# Service Bulletin

Bulletin No. 2005-03

# 21 and 24 Mount Lock Slide

Old lock slide assembly

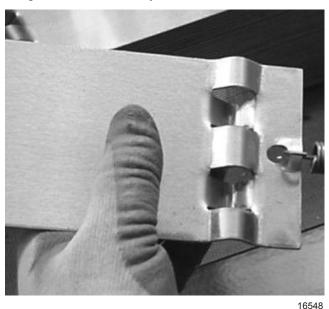
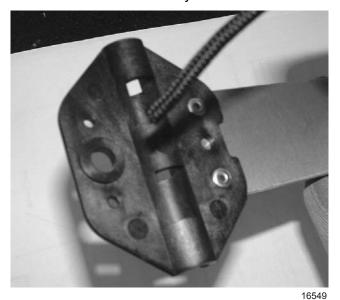
Lock pins may come loose and slide to either side of the bow arm making it difficult to lock and unlock.

The lock slide assembly for these mounts has been updated and new pins are required when installing the new assembly.

The new lock slide assembly is a combination of metal and plastic and the old lock slide pins will not work in the new assembly.

Qty.	Description	Part Number
	1	21 mount lock slide assembly kit	MRK31304S
	1	24 mount lock slide assembly kit	MRK31305S
